**4 LOT SITE PLAN**  
 4252 & 4258 PACES FERRY ROAD  
 LAND LOT 593 & 973, DIST. 17, SECTION 2  
 COBB COUNTY, GEORGIA

**PETITION NO.:** Z-35

### **Z-35 JAMES H. GROOME, JR.**

Re: Stipulations Letter – Shaw Property

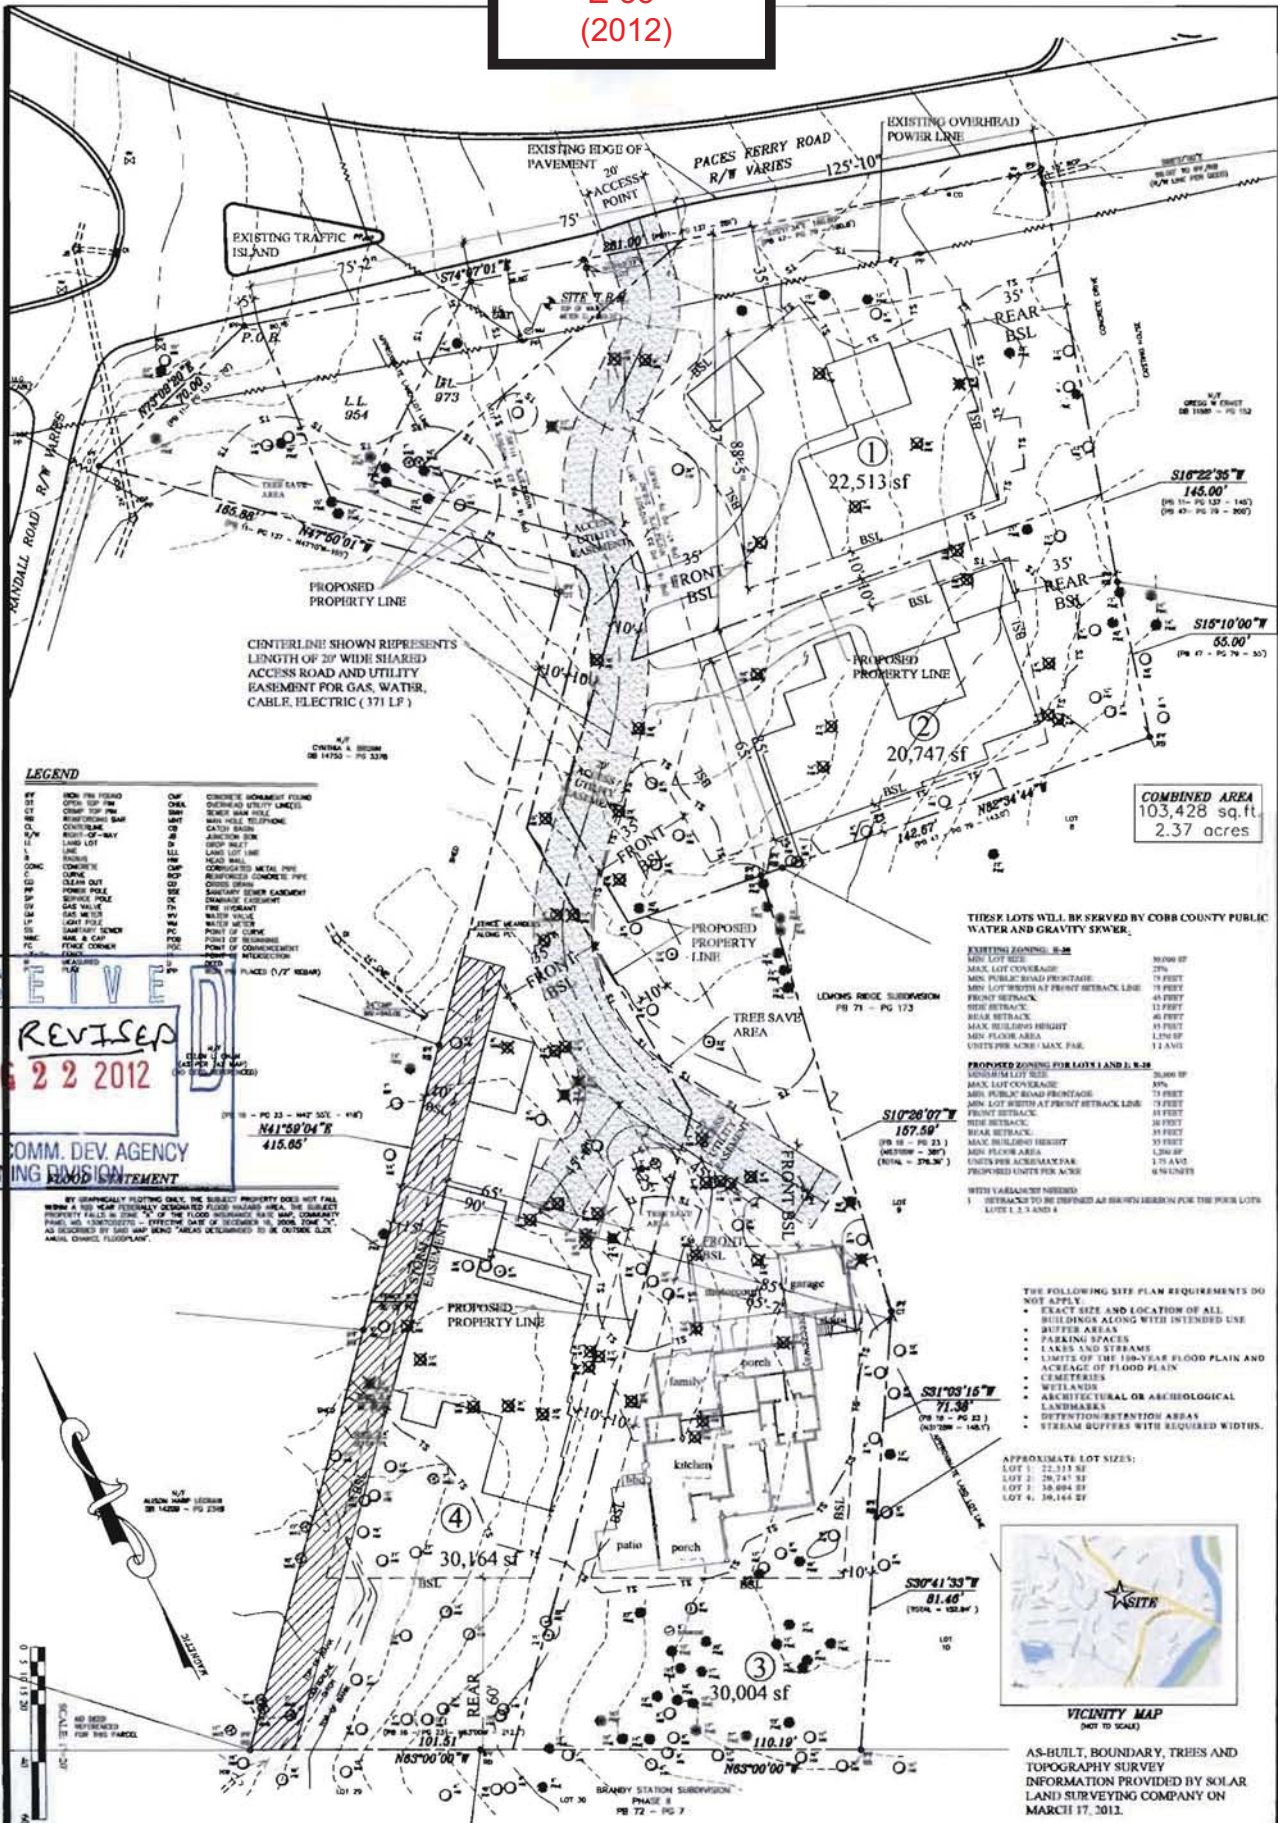
Paces Ferry Road is classified as an arterial and according to the available information the existing right-of-way does not meet the minimum requirements for this classification.

Recommend applicant consider entering into a development agreement pursuant of O.C.G.A. 36-71-13 for dedication of the following system improvements to mitigate traffic concerns: a) donation of right-of-way on the south side of Paces Ferry Road, a minimum of 50' from the roadway centerline.

Recommend curb, gutter, and sidewalk along Paces Ferry Road frontage.

Recommend driveway be located a minimum of 100 feet from intersection of Paces Ferry Road and New Paces Ferry Road.

- B. It is Staff's opinion that the applicant's rezoning proposal will not have an adverse effect on the usability of adjacent or nearby property. With proper accommodations such as the proposed shared access drive to eliminate the additional curb cuts onto Paces Ferry Road and the proposed increased rear setback on lots 3 and 4, any adverse effects may be negated.

- Site plan received by the Zoning Division on August 22, 2012, with the District Commissioner approving minor modifications;
- Fire Department comments and recommendations;
- Stormwater Management Division comments and recommendations;
- Water and Sewer Division comments and recommendations;
- Department of Transportation comments and recommendations;
- Owner/developer to enter into a Development Agreement pursuant to O.C.G.A. § 36-71-13 for dedication of system improvements to mitigate traffic concerns.
